## LONDON BOROUGH OF ENFIELD

### PLANNING COMMITTEE

**Application Number :** P12-01160PLA

**LOCATION:** THE BOURNE CAR PARK, THE BOURNE, LONDON, N14 6QX

Drng.No.BN/ 1

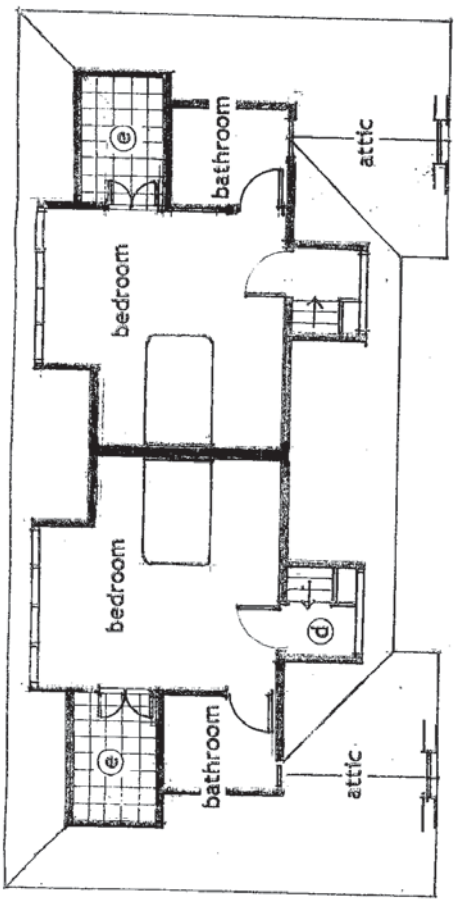
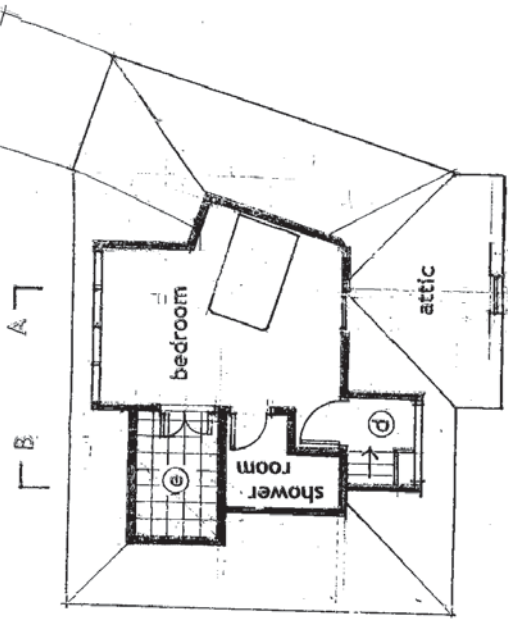
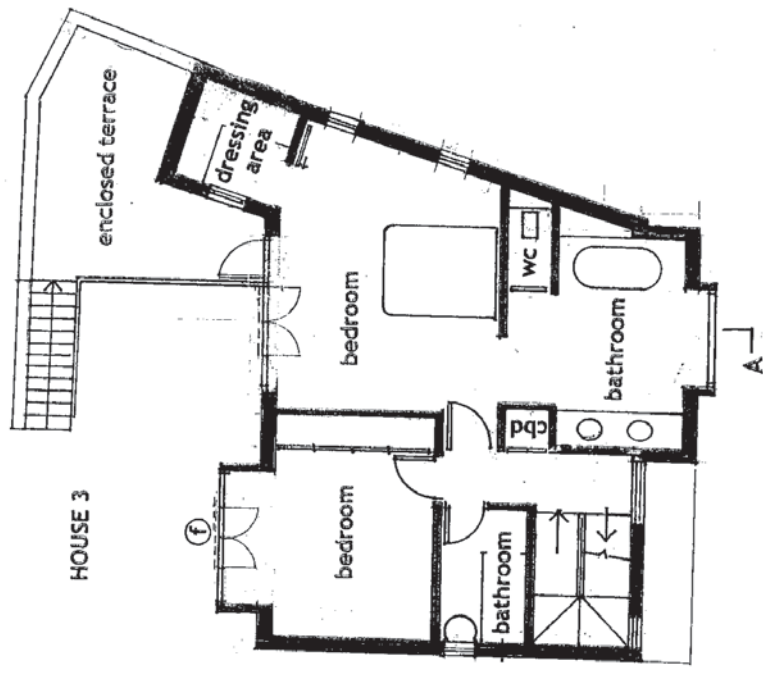
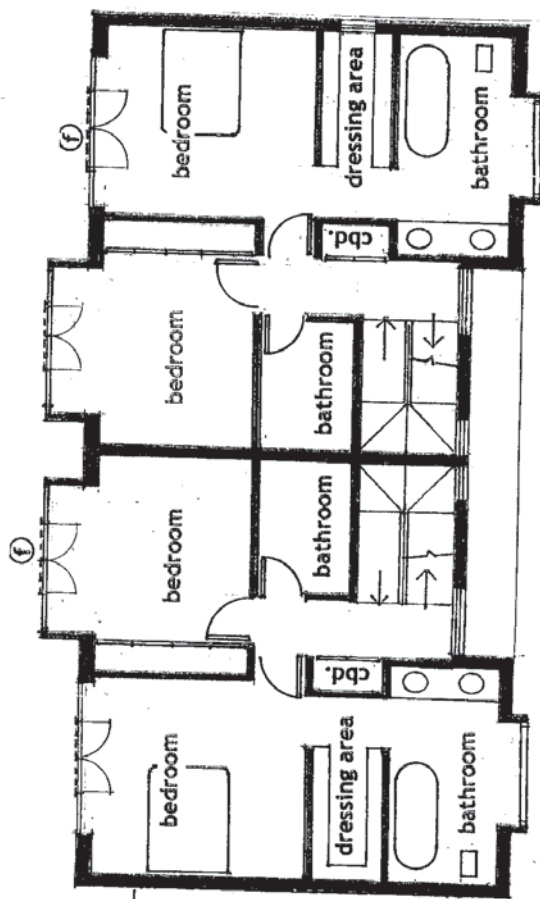
Unless required by any other condition attached to this permission, the parking and turning areas shall be laid out as shown on Drawing No.BN/1 Rev.D and permanently retained for such purposes unless otherwise approved in writing by the Local planning Authority.

7. The areas hatched red on Drawing No.BN/1 Rev.D shall be retained in perpetuity as hard surfaced areas for the purposes of vehicle turning and shall not be used for storage or parking at any time
